Access Compliance Report

Public Rights-of-Way

Intersection ID: 5832	Main Street: N_TRYON_ST	Cross Street: KEN_HOFFMAN_DR	Location: S
ADA ID: FB63445A37F4	Ramp Type: Perp	Initial Pass/Fail: Fail	Overall Compliance: No
Severity Score: 10			
Codes/Mitigation Info/Possible Solution		Field Measurements/Component Compliance

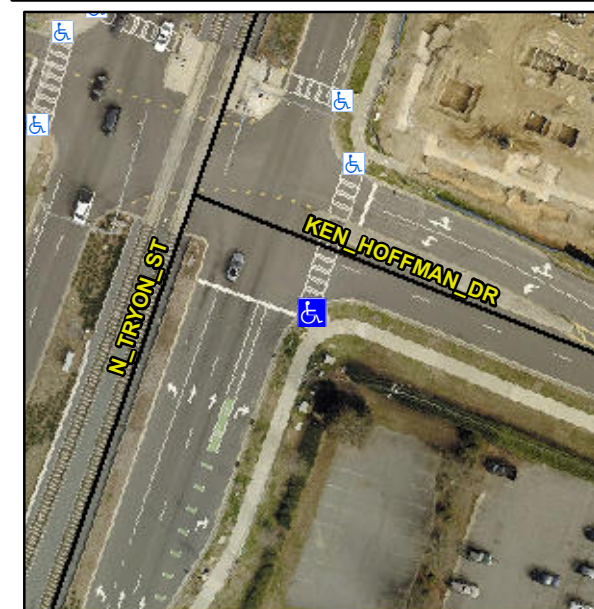
R304.5.1

Compliance	Description	Data	Compliance	Description	Data
N/A	Ramp Length (in)	97.0	Yes	Ramp Slope (%)	5.9
No	Ramp Width (in)	47.5	Yes	Ramp XSlope (%)	2.6
N/A	Flare Type LT	N/A	N/A	Flare Type RT	N/A
N/A	Flare Slope LT (%)	N/A	N/A	Flare Slope RT (%)	N/A
N/A	Flare Traversable LT?	N/A	N/A	Flare Traversable RT?	N/A
N/A	Landing Length (in)	N/A	N/A	DWS Provided?	N/A
N/A	Landing Width (in)	N/A	N/A	DWS Contrast?	N/A
N/A	Landing Slope (%)	N/A	N/A	DWS Length (in)	N/A
N/A	Landing X Slope (%)	N/A	N/A	DWS Full Width?	N/A
N/A	Landing Curb? (Y/N)	N/A	N/A	DWS Offset (in)	N/A
N/A	Shared Landing?	N/A			
N/A	Gutter Ponding?	N/A	N/A	Gutter Slope (%)	N/A
N/A	Gutter Lip Ht (in)	1.5	N/A	Gutter X Slope (%)	N/A
N/A	Painted X Walk1?	No	N/A	Painted X Walk2?	N/A
	X Walk 1 Direction	To NE		X Walk 2 Direction	N/A
N/A	X Walk 1 Width (in)	N/A	N/A	X Walk 2 Width (in)	N/A
	X Walk 1 Slope (%)	1.1		X Walk 2 Slope (%)	N/A
	X Walk 1 X Slope (%)	3.7		X Walk 2 X Slope (%)	N/A

Remove & Replace Entire Ramp.
